## MEMORANDUM

**SUBJECT: BZA Case 18448 Supplement**

On November 27, 2012, the Board of Zoning Adjustment (BZA) held its public hearing on this request for variance relief from § 401.3 to convert the existing two-story row dwelling at 1221 Otis Place NW into a three-story, four-apartment building. The Office of Planning (OP) report dated November 20, 2012, did not support this request. During testimony, neighboring property owner Elias Wolfberg testified that the existing dwelling currently exceeds the maximum 60% lot occupancy allowed for row dwellings in the R-4 district under § 403.

Front step and landing

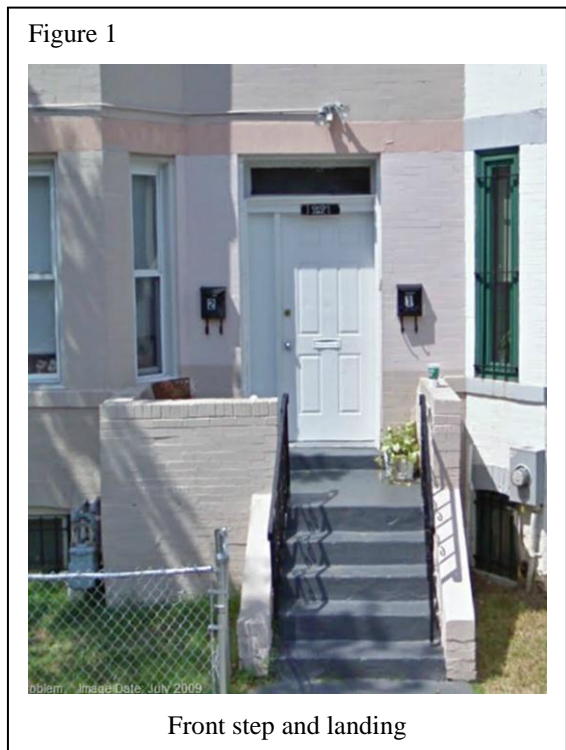
OP calculations based on the submitted plat indicate that this row dwelling originally occupied approximately 57.5%<sup>1</sup> of the lot and 62.5% with the 5-foot addition, rather than 65.5%.<sup>2</sup> The existing dwelling is setback 5-8 feet from the public right-of-way. This space in front of the dwelling is open to the street and surrounded on three sides by property lines, making it consistent with the regulation definition of an open court. This court area is 18-feet wide, more than the minimum width of 10 feet required in the R-4 district for row dwelling lots under § 406. Because the court area is conforming, it is not included in building area and lot occupancy calculations for this site.

<sup>2</sup> The front stair landing was excluded from the building area calculation because, based on the front elevation (refer to figure 1 above), the front landing is the same height as the cellar windows and ceiling which less than 4 feet above-grade.
